| SUNDRY NOTICES AND REPORTS ON WELLS <i>Do not use this form for proposals to drill or to re-enter an abandoned well. Use Form 3160-3 (APD) for such proposals.</i> | | 5. Lease Serial No. NMNM77063 |

| 1. Type of Well <input checked="" type="checkbox"/> Oil Well <input type="checkbox"/> Gas Well <input type="checkbox"/> Other | | 8. Well Name and No. INGA 33 FED COM/722H |

EOG respectfully requests an amendment to our approved APD for this well to reflect the following changes:

**Inga 33 Fed Com 722H****Revised Permit Information 11/02/2023:**

Revised Wellbore

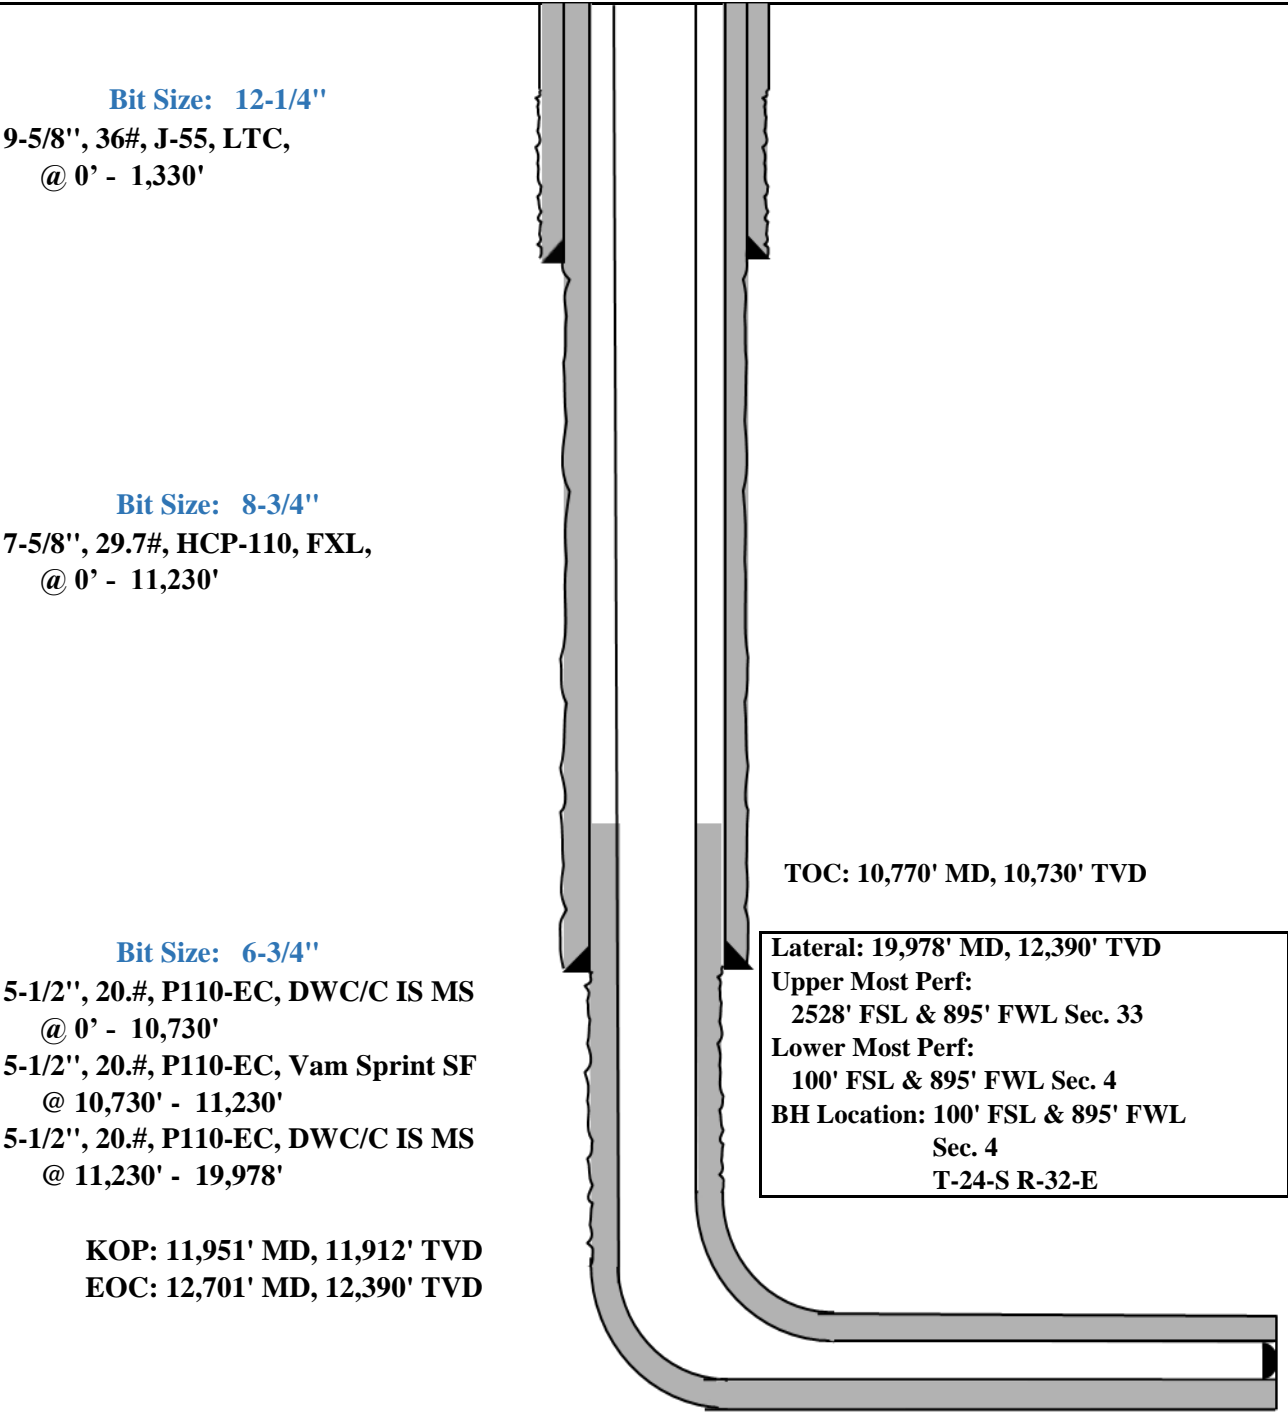
Change BHL from T-24-S, R-32-E, Sec 4, 100' FSL, 1254' FWL, Lea Co., NM,
to T-24-S, R-32-E, Sec 4, 100' FSL, 895' FWL, Lea Co., N.M.

Change target formation to Wolfcamp U2.

Update casing and cement program to current design.
